FCC ID: NEH-96000NB

Changes to Wulfshberg Electronics, Inc. Radio:

For Narrow Band Operation and

Assignment of new FCC ID Number

SCHEMATIC	APPROVED BY: _____	DESIGNED BY: LAJ
DATE: 6/98	REVISED	
SCHEMATIC - RADIO		
OFST8	SCHEMATIC NUMBER

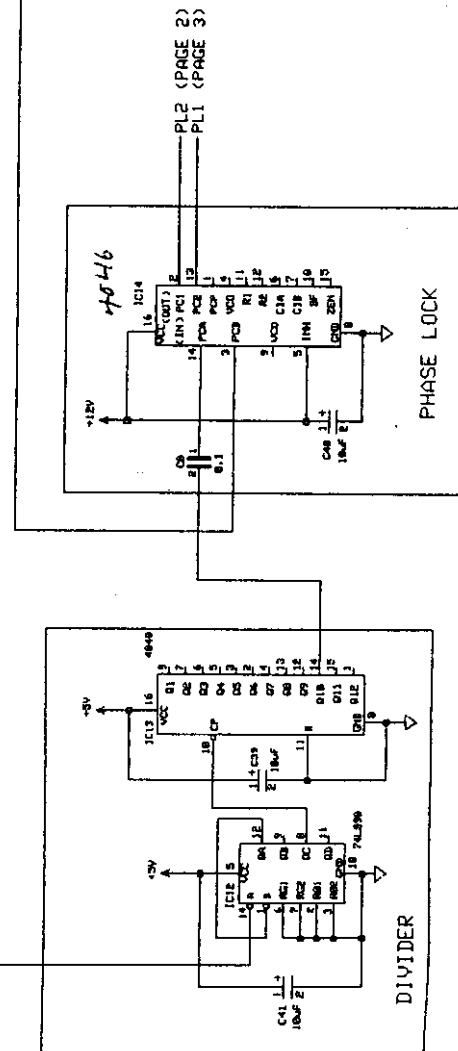
1. Replaced master oscillator with a TCXO made by Monitor Products, Inc., Oceanside, CA.
2. Changes one switch on front panel of the control head to change deviation limit level; i.e., (1) up position for narrow band deviation limit 1.5 kHz. Labeled "NB". (2) down position for wide band limit 3.0 kHz deviation. Labeled "WB".

1. Changed IF filter to narrow bandwidth for operation with a 12.5 kHz band spacing.
